Access Compliance Report

Public Rights-of-Way

Intersection ID: 16818	Main Street: MONROE_RD	Cross Street: GLENDORA DR	Location: NE
ADA ID: CD6F2294D263	Ramp Type: PerpDiag	Initial Pass/Fail: Fail	Overall Compliance: No
		Severity Score: 42.5

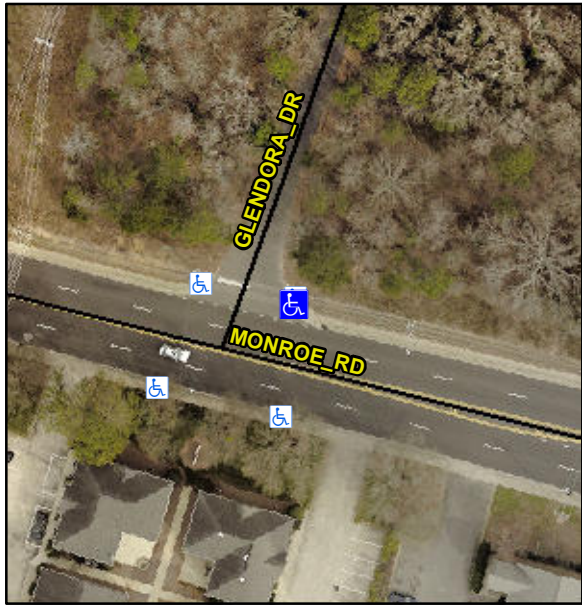
Codes/Mitigation Info/Possible Solution			Field Measurements/Component Compliance					
	Possible Solutions:		Compliance	Description	Data	Compliance	Description	Data
	Remove & Replace Curb Ramp With Two New Directional Ramps or Equivalent.		N/A	Ramp Length (in)	59.0	No	Ramp Slope (%)	10.9
			No	Ramp Width (in)	35.0	No	Ramp XSlope (%)	6.6
			N/A	Flare Type LT	N/A	N/A	Flare Type RT	N/A
			N/A	Flare Slope LT (%)	N/A	N/A	Flare Slope RT (%)	N/A
			N/A	Flare Traversable LT?	N/A	N/A	Flare Traversable RT?	N/A
			N/A	Landing Length (in)	N/A	N/A	DWS Provided?	N/A
			N/A	Landing Width (in)	N/A	N/A	DWS Contrast?	N/A
			N/A	Landing Slope (%)	N/A	N/A	DWS Length (in)	N/A
			N/A	Landing X Slope (%)	N/A	N/A	DWS Full Width?	N/A
Surveyor Notes:		N/A	N/A	Landing Curb? (Y/N)	N/A	N/A	DWS Offset (in)	N/A
PROW/ADA:		Not Found, R304.5.1, R304.2.2, R304.5.3	N/A	Shared Landing?	N/A	N/A	Gutter Slope (%)	N/A
			N/A	Gutter Ponding?	N/A	N/A	Gutter X Slope (%)	N/A

N/A	Gutter Lip Ht (in)	N/A	N/A	Painted X Walk2?	No
			N/A	Painted X Walk1?	No	N/A	X Walk 2 Direction	To SW
			N/A	X Walk 1 Direction	To NW	N/A	X Walk 2 Width (in)	N/A
			N/A	X Walk 1 Width (in)	N/A	N/A	X Walk 2 Slope (%)	6.1
				X Walk 1 Slope (%)	1.8		X Walk 2 X Slope (%)	2.5
				X Walk 1 X Slope (%)	4.3		Ramp inside XWalk2?	N/A
			N/A	Ramp inside XWalk1?	N/A	N/A	Clear Space?	N/A
				Road Slope (%)	4.6	N/A	Clear Space to XWalk (in)	N/A
				Road X Slope (%)	3.7	N/A	Storm Grate/Utility Hazard?	N/A
			N/A	Any Obstructions?	N/A	N/A	Storm Grate/Utility Type	
				Obstruction Type		N/A		N/A
						Yes	Surface Condition? (G/P)	Good
Total Cost:		\$ 3200.00						
Street 1 Name		GLENDORA DR						
Stop Condition-Street 2		StopSign						
Street 2 Name		MONROE RD						
Stop Condition-Street 1		None
